**5-C-21-HZ**  
**APPLICATION FOR CERTIFICATE OF APPROPRIATENESS**

**2104 Washington Pk. 37917**  
**Edgewood-Park City H**

# Staff Report

File Number: 5-C-21-HZ

WINDOWS TO BE REPLACED ARE MARKED BELOW

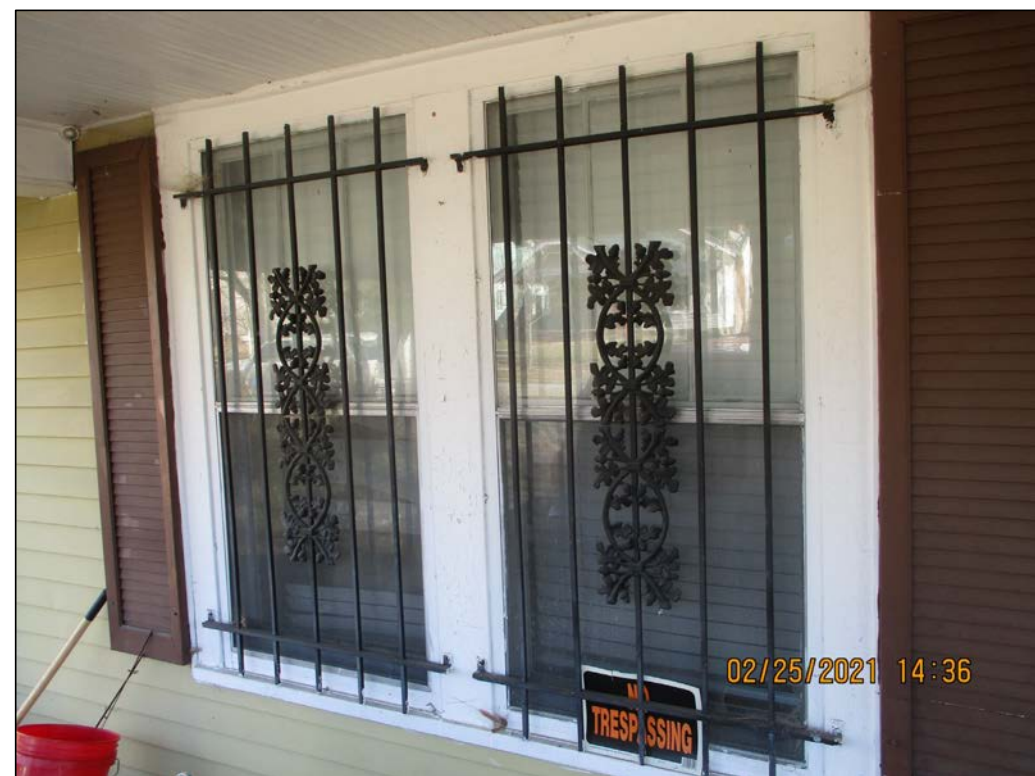
Façade windows (AW1-4)

Right side elevation windows (DW3 and DW2)

Rear elevation window (CW1)

Left side elevation windows (BW1-4)

Rear elevation windows (CW3 & CW5)
